**DOMINION NUCLEAR CONNECTICUT, INC.**  
**MILLSTONE POWER STATION UNIT 3**  
**RESPONSE TO REQUEST FOR ADDITIONAL INFORMATION**  
**REGARDING PROPOSED TECHNICAL SPECIFICATION CHANGES FOR**  
**IMPLEMENTATION OF ALTERNATE SOURCE TERM**

**PROPOSED TECHNICAL SPECIFICATION CHANGES**  
**IMPLEMENTATION OF ALTERNATE SOURCE TERM**  
**RESPONSE TO REQUEST FOR ADDITIONAL INFORMATION**

**DOMINION NUCLEAR CONNECTICUT, INC.**  
**MILLSTONE POWER STATION UNIT 3**

**QSS SPRAYED VOLUME PERCENTAGE**  
**RSS AND QSS SPRAYED VOLUME**

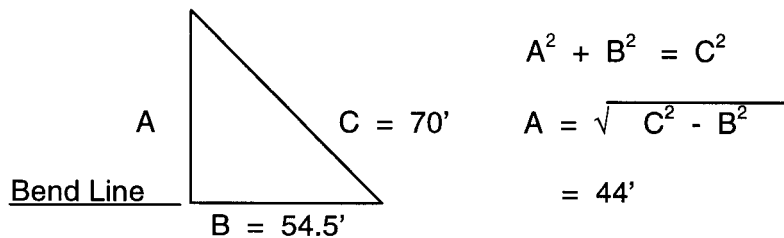
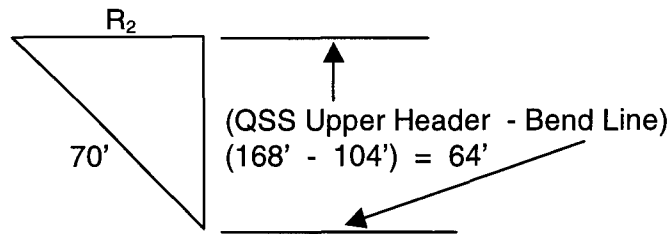
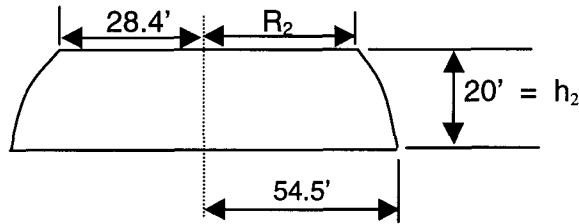
Provide a description, or the calculation title, of the QS LAR volume coverage fraction in sufficient detail to understand the volume values and the QS coverage fractions, and to what extent, if any, the values derived are considered to be conservative for the intended use. The current FSAR calculation would be sufficient if the staff's interpretation of the reduced LAR value is correct. If the methodology employed in calculation 369 was used, describe the difference in sufficient detail to understand the new QS value.

Provide a description, or the calculation file, of the RS LAR volume coverage fraction in sufficient detail to understand the volume values and the RS coverage fractions, and to what extent, if any, the values derived are considered to be conservative for the intended use. If the methodology employed in calculation 369 was used, describe the difference in sufficient detail to understand the RS value.

The methodology utilized in Calculation US(B)-369 was not used. The methodology used is consistent with the current plant license. This methodology is documented in Calculation US(B)-341. The Calculation US(B)-341 methodology is described above in the response to Question 1. Conservatism present in the calculation include application of the maximum containment free volume and no credit for QSS spray reaching certain portions of containment (e.g. containment annulus area). An example calculation of the QSS sprayed volume percentage is provided in Enclosure 1.

The methodology utilized in Calculation US(B)-369 was not used. The methodology used in calculating the sprayed volume is consistent with the methodology utilized in Calculation US(B)-341. Only the combined spray coverage for the Recirculation Spray System (RSS) and QSS is credited in the analysis. As discussed in the introduction of the RAI, after QSS is secured, even though the RSS continues to operate, no credit is taken for iodine removal. An RSS alone spray coverage volume has not been determined or used. Relative to the RSS and QSS spray coverage, this methodology is documented in Calculation US(B)-341. The Calculation US(B)-341 methodology is similar to that described in the response to Question 1 for QSS. The RSS headers are physically located above the crane wall. A significant portion of the RSS spray will fill the containment annulus area (i.e. the area between the outside of the crane wall and the containment liner). A 50% spray coverage factor is used for the containment annulus area. This factor includes congestion for equipment. Conservatism present in the calculation include application of the maximum containment free volume and no credit for either RSS or QSS spray reaching certain portions of containment (e.g. a significant portion of the containment annulus area). An example calculation of the RSS and QSS sprayed volume is provided in Enclosure 1.

The containment sprayed volume was determined as documented below:

Note: The inside crane wall diameter specified is for elevations below the operating deck elevation of 51' - 4". The crane wall inside diameter is 110' from elevation 51' - 4" and higher. This calculation utilizes the smaller more conservative diameter of 109'

$$h = 44' + (104' - 51.33') = 96.67'$$

$$V_1 = \pi * \frac{D^2}{4} * h = \pi * \frac{109^2}{4} * 96.67 = 902,000 \text{ ft}^3 \text{ (Volume of a right cylinder)}$$

$$V_2 = 1/6 * \pi * 20 * [(3 * (54.5)^2 + 3 * (28.4)^2 + (20)^2)] = 122,800 \text{ ft}^3$$
